DESIGN ADVISORY BOARD Tuesday June 14, 2016 at 3:00 PM Conference Room 12, City Hall, Burlington, VT Agenda

To: The Design Advisory Board
From: Mary O'Neil, AICP, Principal Planner
RE: ZP16-1258SP; 49 Church Street (Burlington Town Center)
Date: June 14, 2016

To: The Design Advisory Board
From: Mary O'Neil, AICP, Principal Planner
RE: ZP16-1253CA; 56 Ledgemere Street
Date: June 14, 2016

FIRST FLOOR PLAN PROPOSED

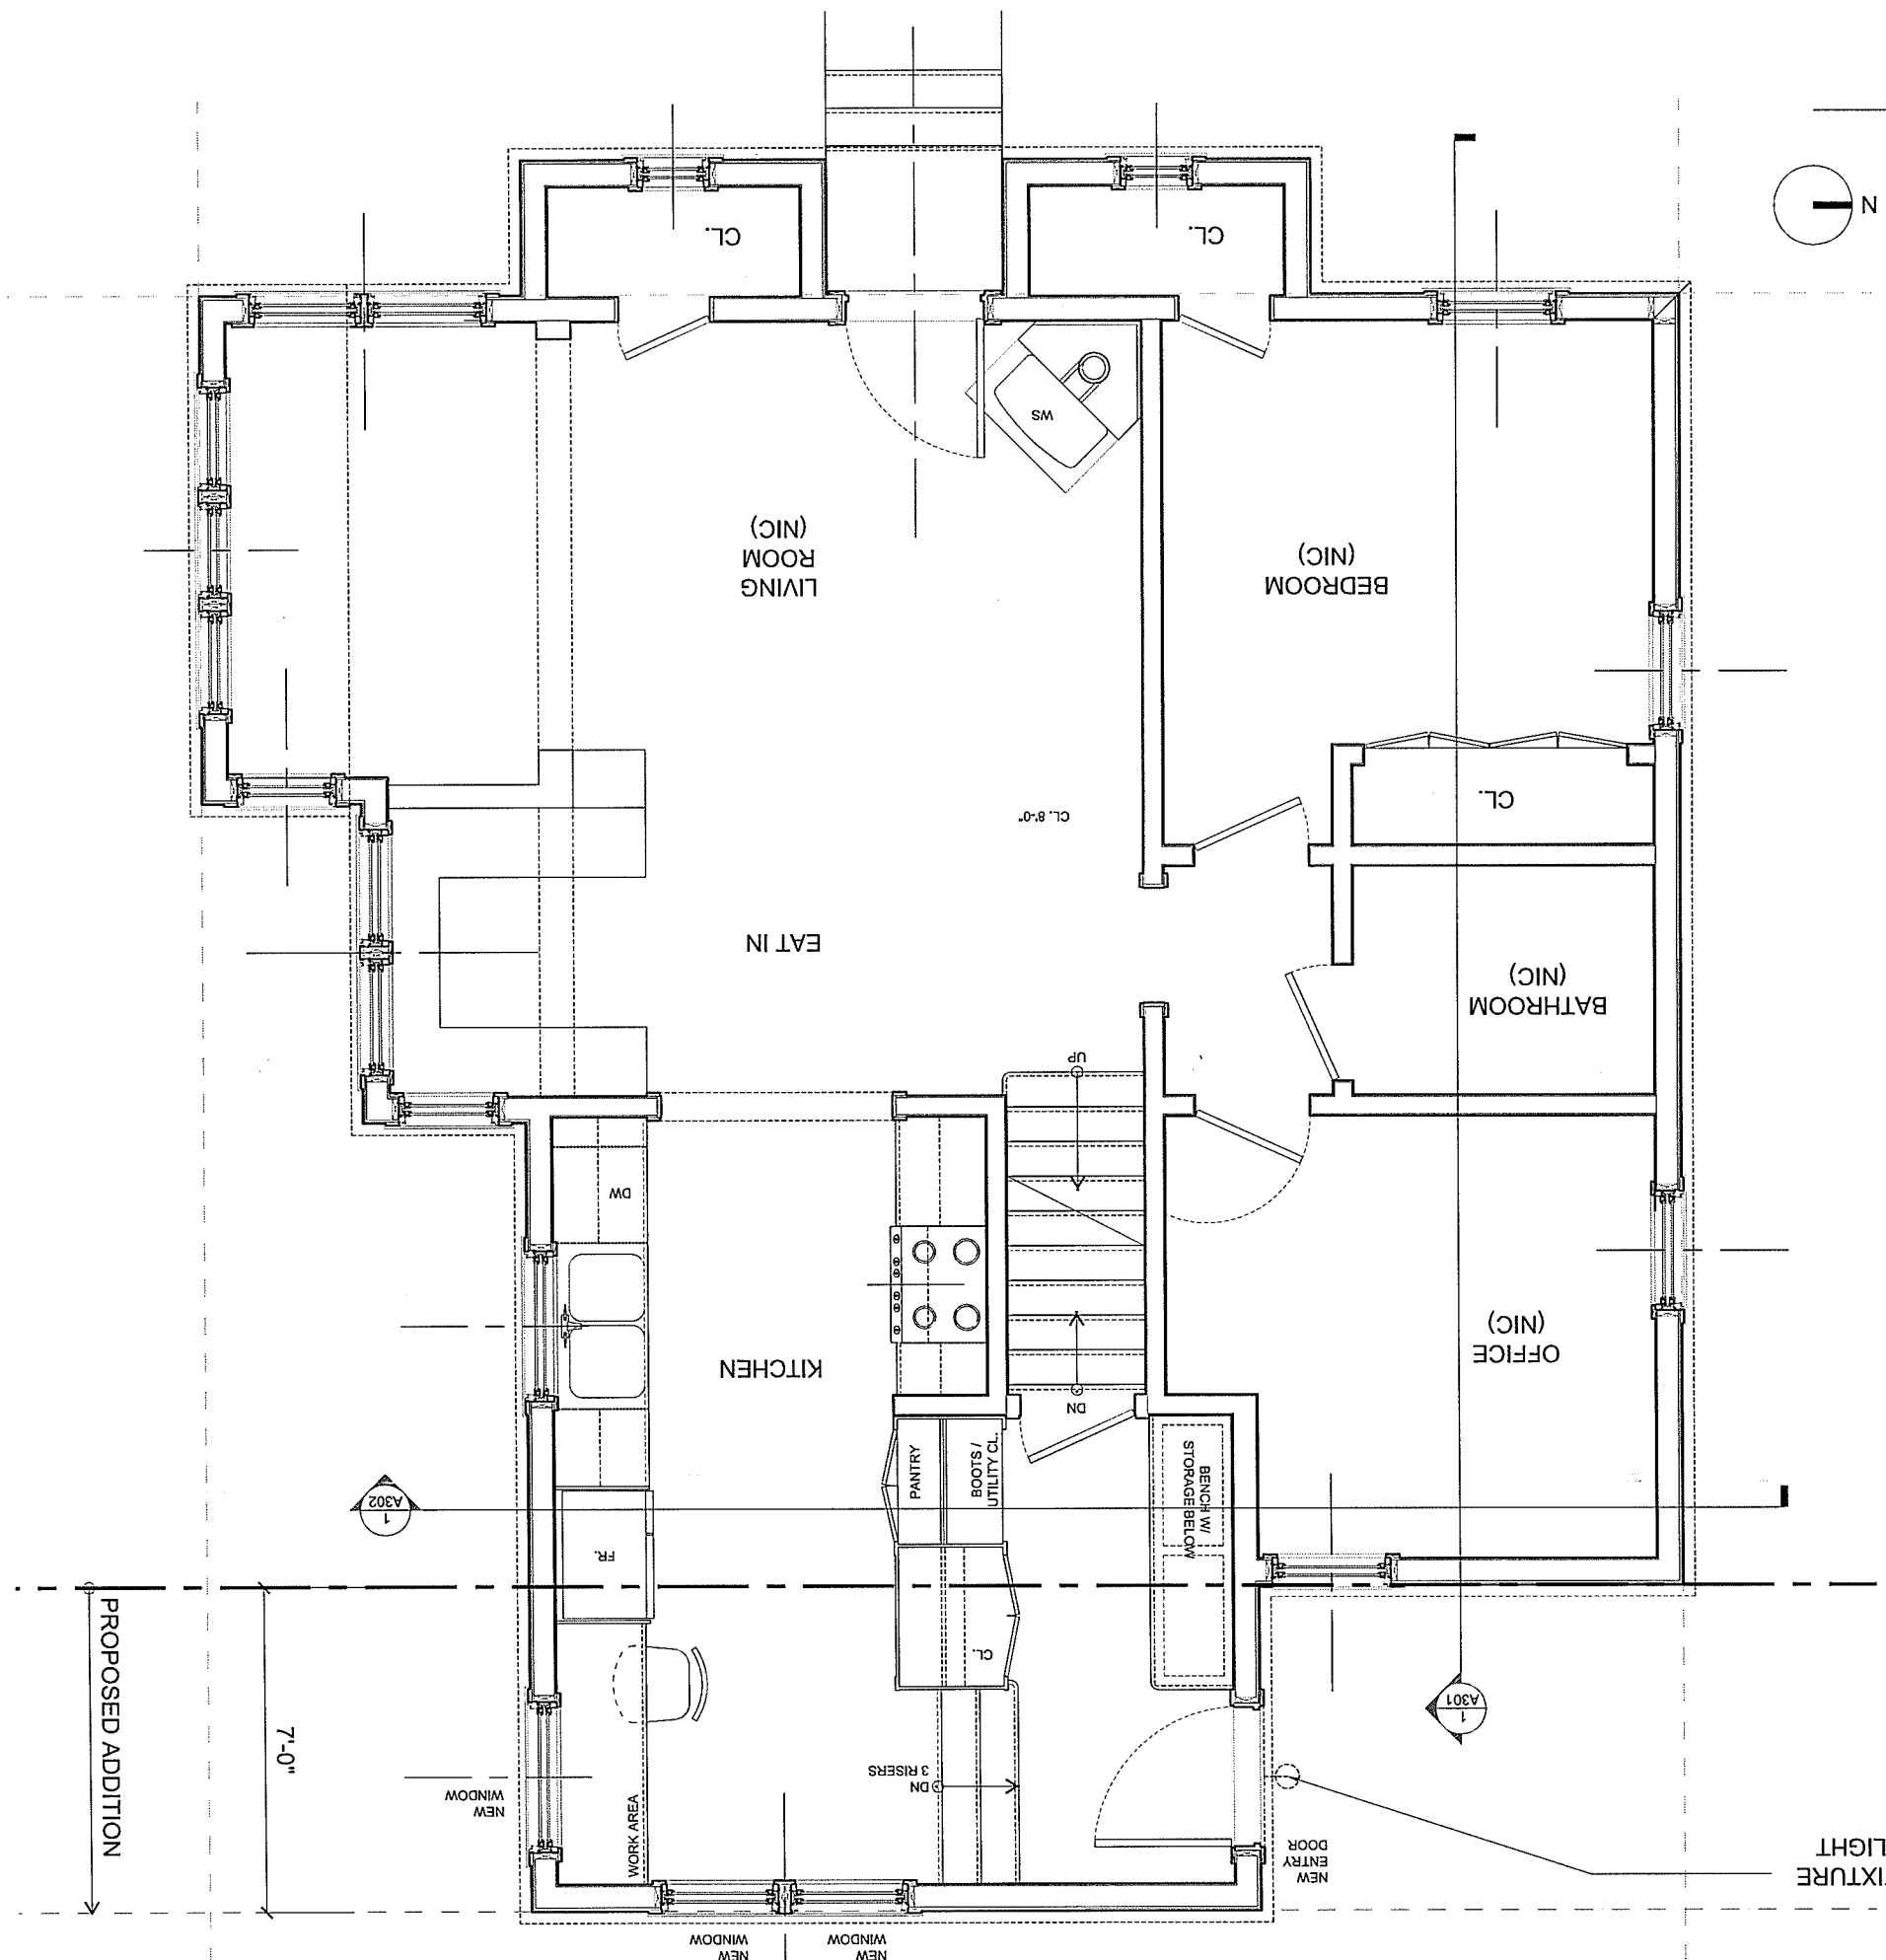
No change to the existing vehicular access is proposed. To capture additional coverage for the kitchen addition, the driveway is proposed to be narrowed in width. The applicant has identified those specific dimensions on the revised site plan to confirm the coverage change.

A residential scale lighting fixture has been proposed for the rear entrance. No change is proposed to the front entry.

A 201

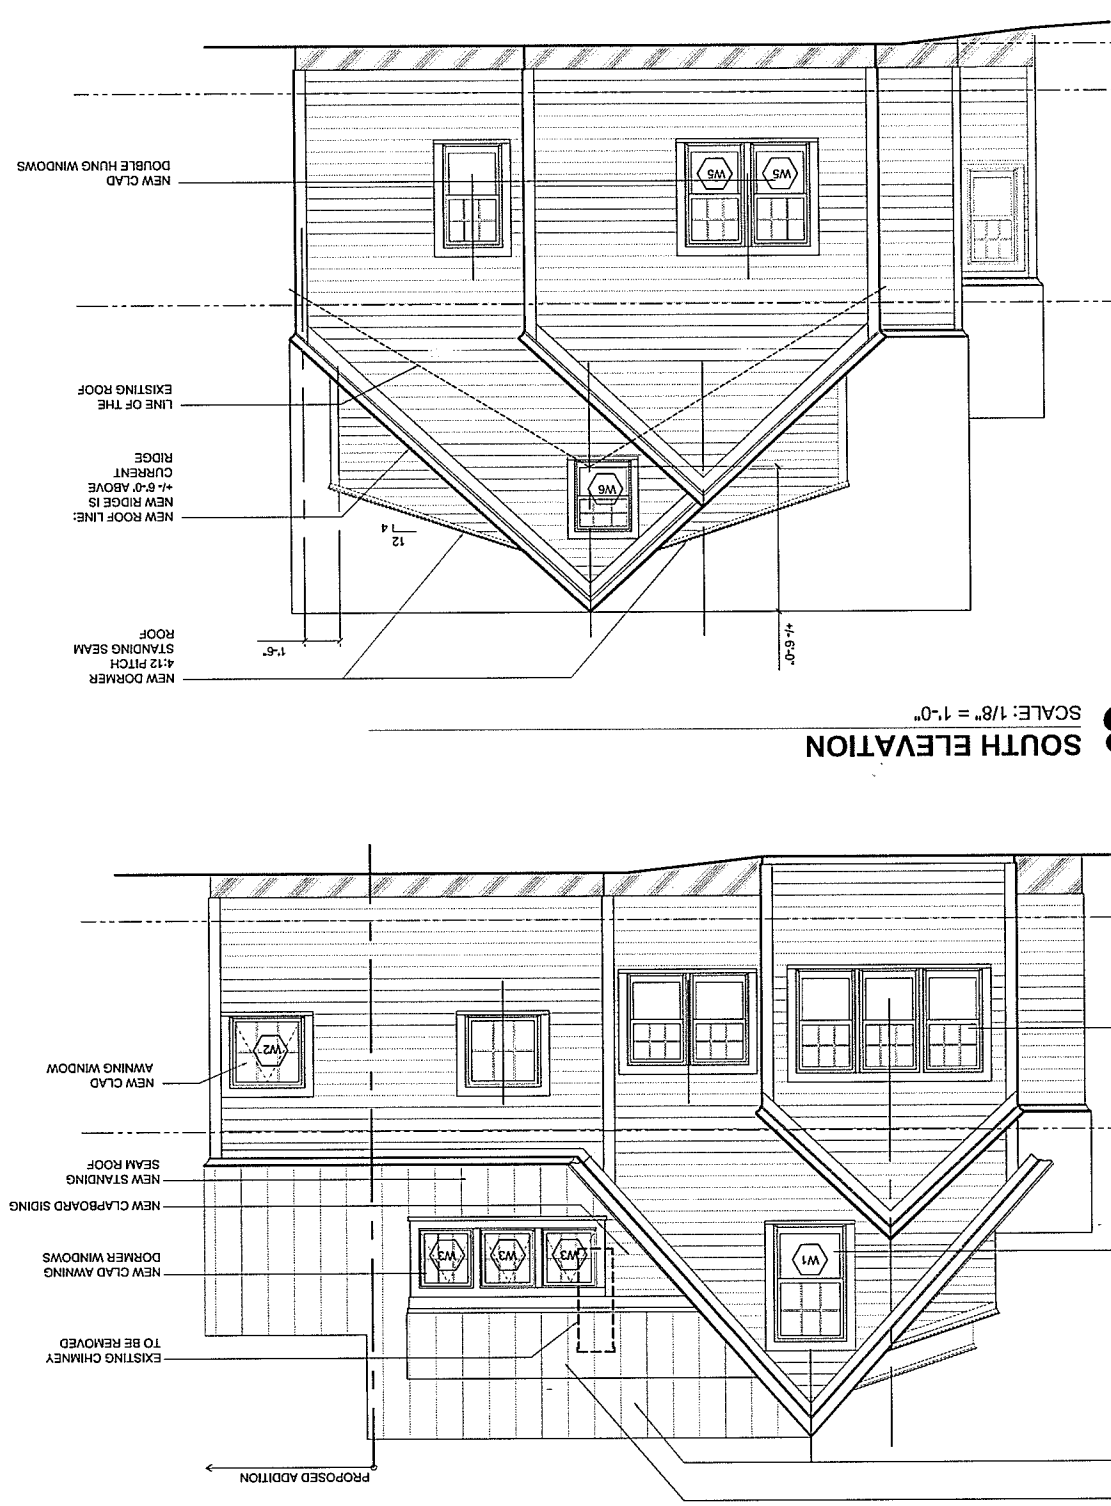
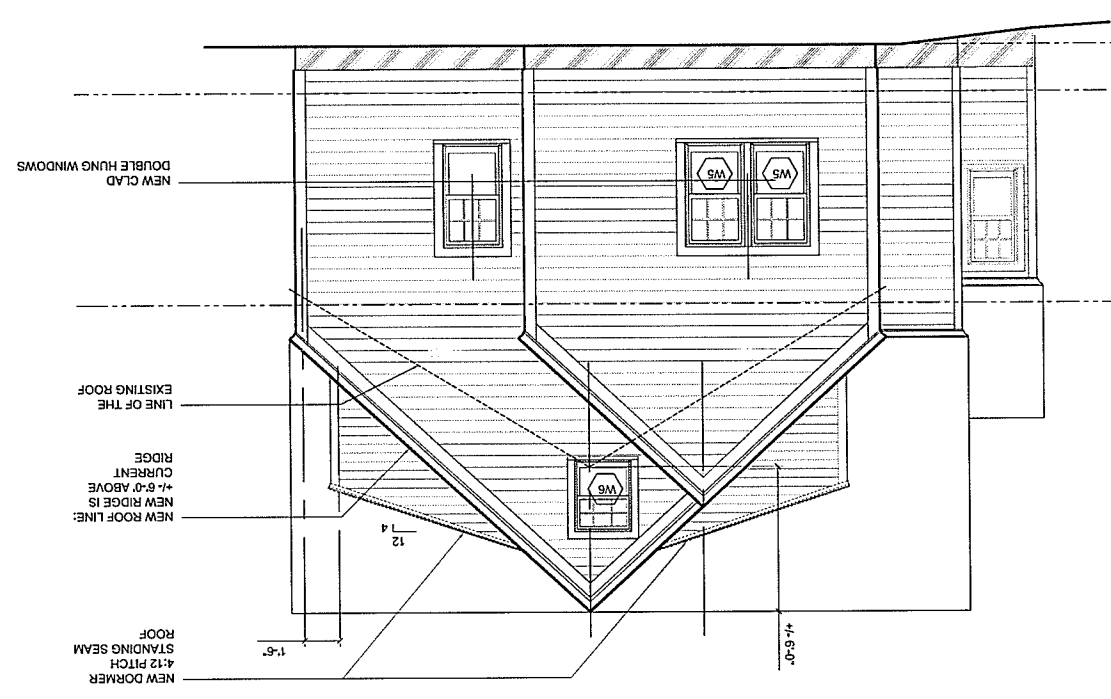
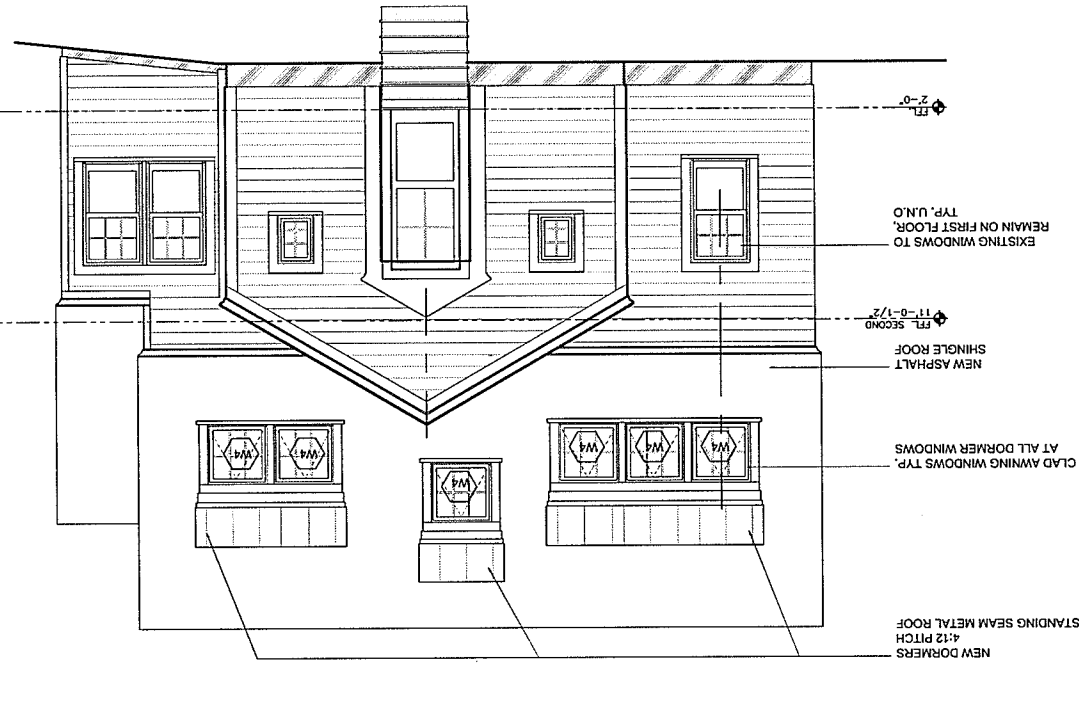
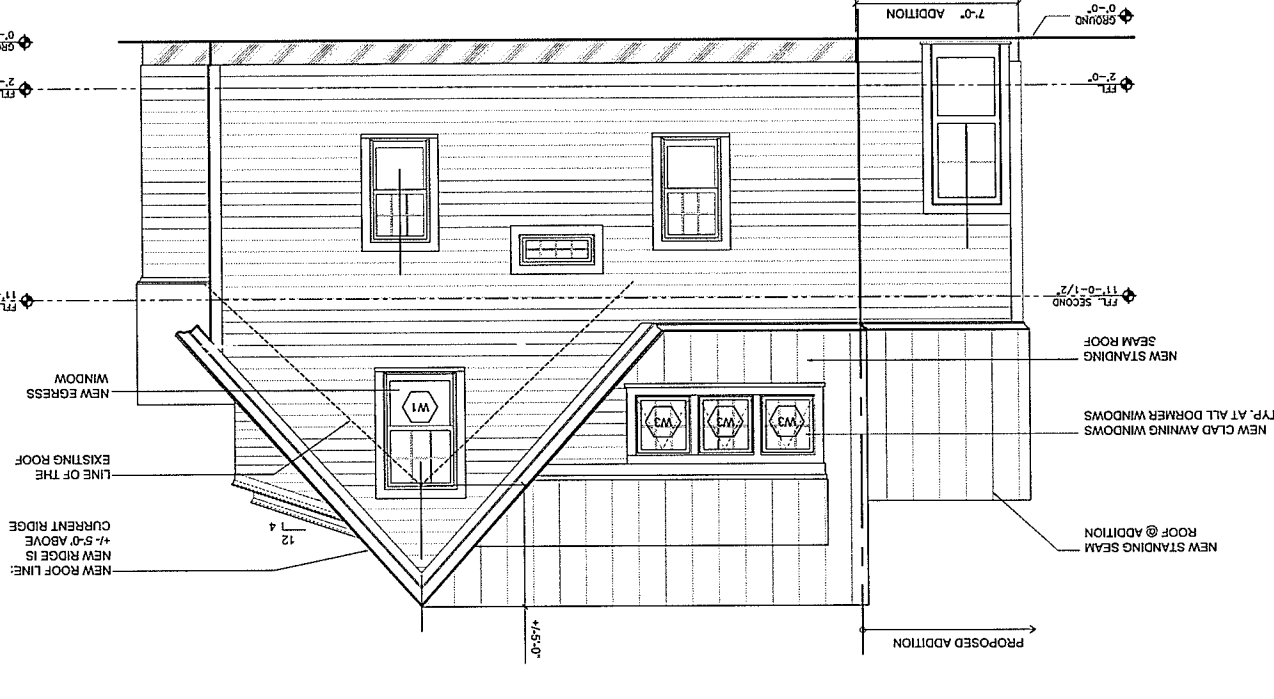
Windows are proposed to be clad awning/casement/double hung, as noted in plan A201. New clapboard siding is identified for the dormers. The roof is proposed to be standing seam, which may be functionally problematic due to snow slide (particularly over the rear door on the north elevation.)

The dormers and the roof pitch are not consistent with the original and extant character of the property. While similar modifications are frequently approved for rear or secondary elevations where they are invisible from the public right-of-way, substantial modification that alters the principal façade is to be avoided. Additionally, the

MB – Motion: The plan as presented significantly alters the character of the house, but the projects is recommended for approval if center dormer is eliminated, 3 gang dormer changed to 2 gang, all 5 recommended conditions of staff included.
